## REMARKS

Claims 1-20, as amended, are pending for the Examiner's consideration. Claims 1, 4, 15, and 18 have been amended for clarification purposes. Claim 18 has also been amended to respond to an informality rejection. New claims 19-20 have also been added to the application. The specification has also been amended as noted above. The amendments are supported throughout the specification. As these amendments do not introduce new matter, Applicant respectfully requests favorable reconsideration and allowance of the application in view of the above amendments and the following remarks.

**FIG. 1**

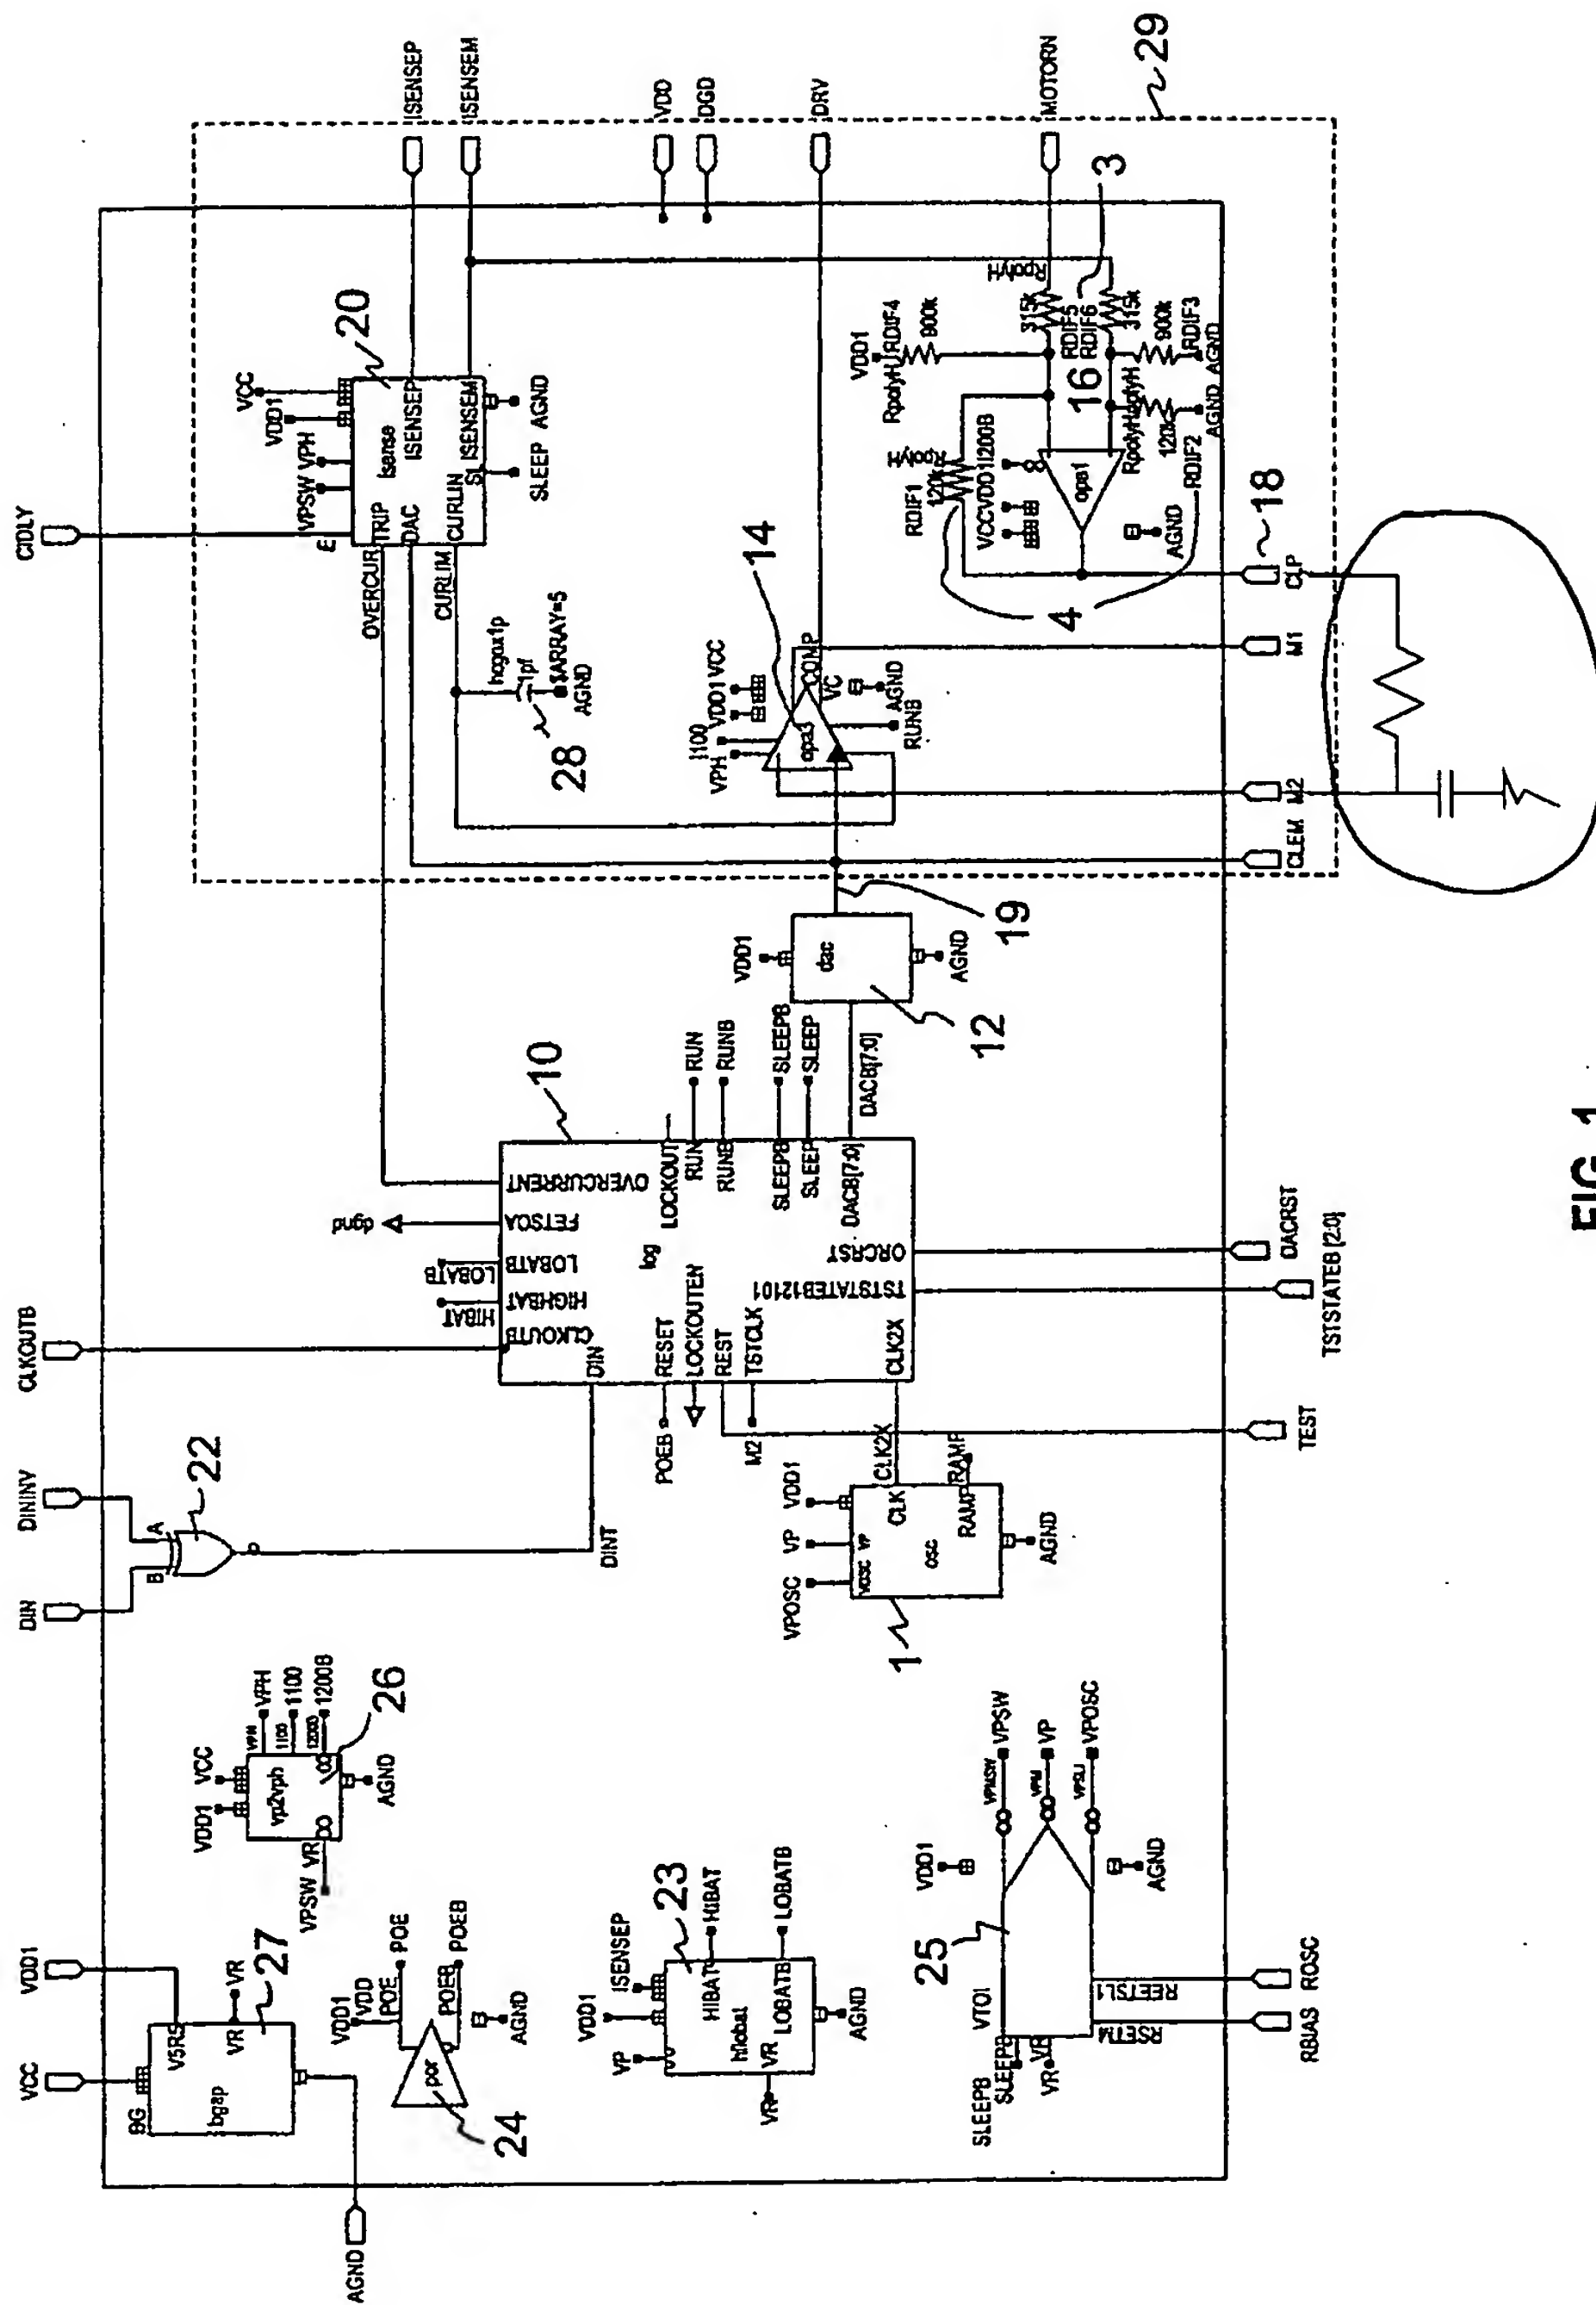
In the Office Action, the drawings are objected to because, according to the Examiner, they fail to show "how CLP is low pass filtered and where the output of the filtered signal connects to OPA3 14." In response, an amended version of FIG. 1 is attached, one with the amendment noted in red and one replacement drawing.
